Concept SSDA Access Design Assessment Report

CUDGEGONG ROAD STATION PRECINCT SOUTH
ROUSE HILL
NSW 2155

Project: Cudgegong Road Station Precinct South, Rouse Hill NSW 2155
Document Type: Access Design Assessment Report
Report Number: P218_043-4 (ACCESS) LD

Figure 02 –Pedestrian and Cycle Network

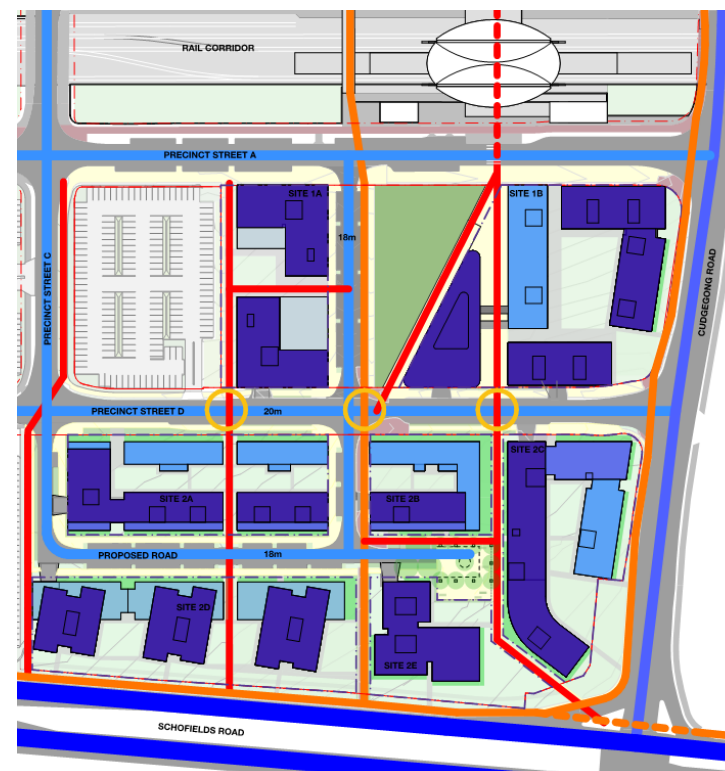
As proposed in the Civil Package provided by AECOM, the paths for exclusive pedestrian use are not less than ~1800mm wide, the bike path is ~3000mm wide and the combined foot and bike path is ~3500mm wide. The width of the paths are inclusive of the kerb on both sides, thus the unobstructed width might be slightly reduced.

These proposed widths are acceptable for all users and will allow wheelchair users to pass one another perform turns where necessary.

Figure 03 – Gradients

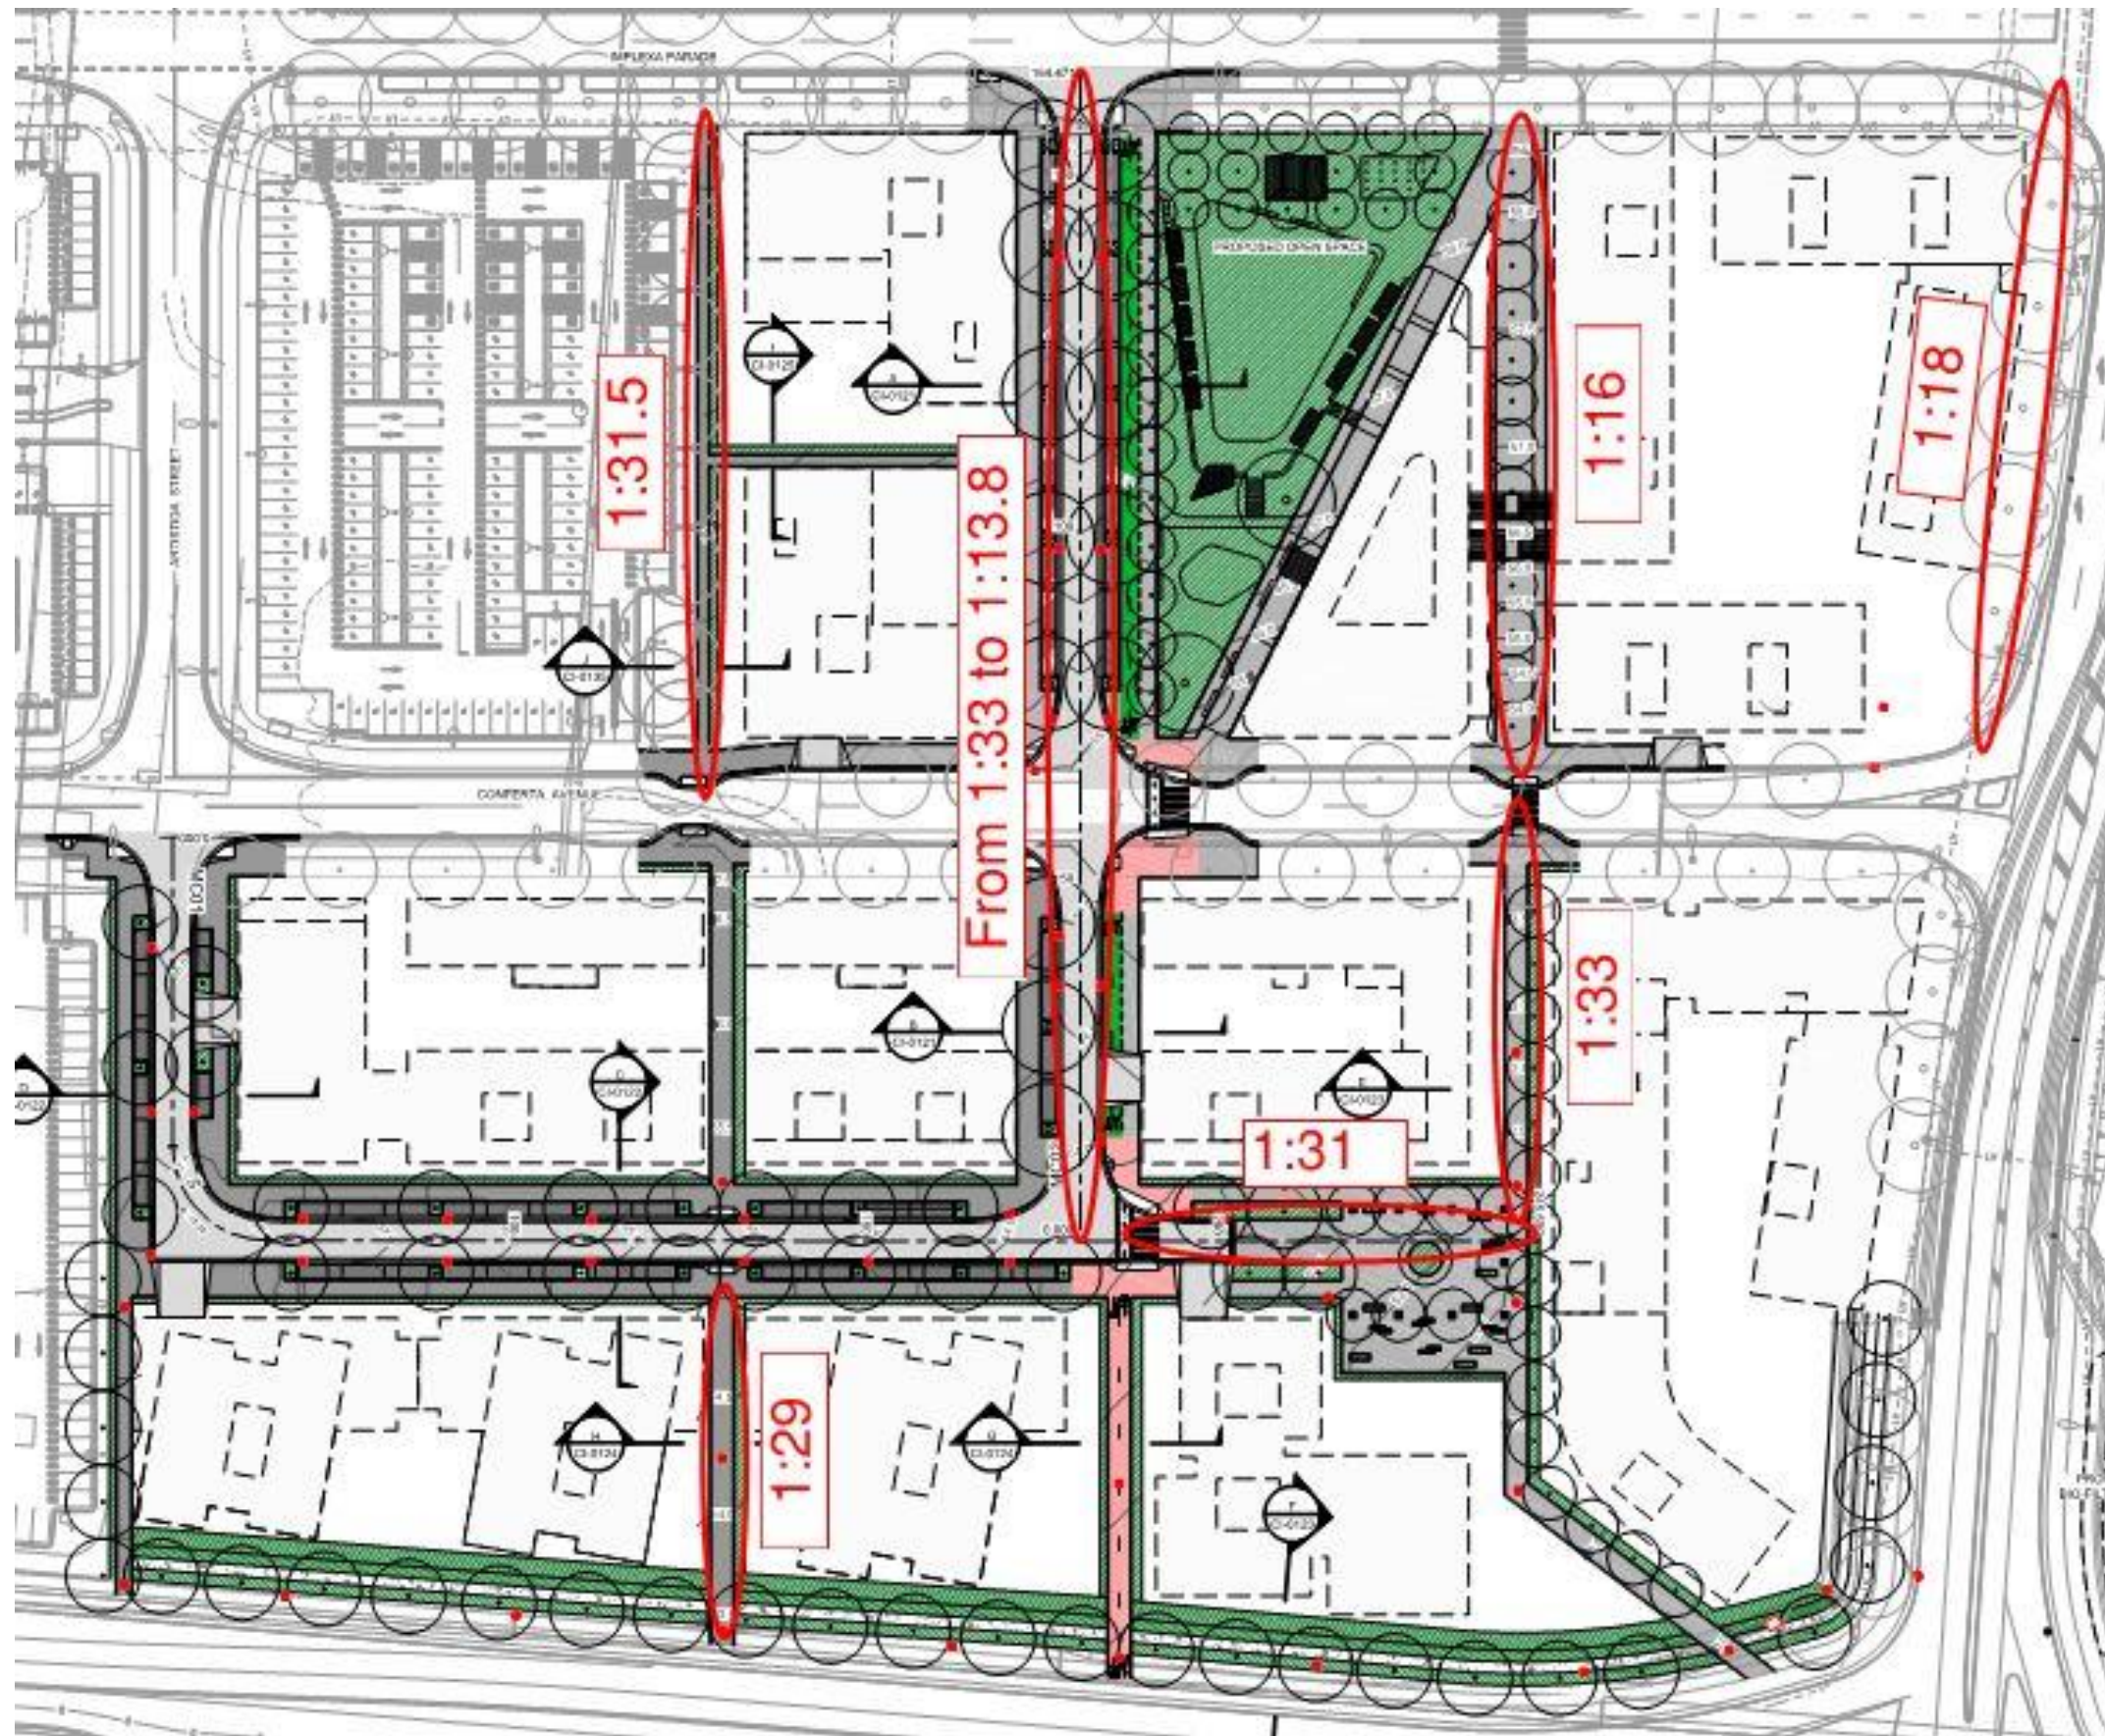
In accordance with the longitudinal sections and contour lines provided by AECOM, there is a need to review approximate gradients of the following areas circled in **red** in **Figure 03** below.

Confirmation of these gradients via longitudinal sections of the proposed paths will be required as the design progresses at detailed development application stage. Accessibility features may be required depending on the gradient of the path, as summarised above and in **Appendix A1**.
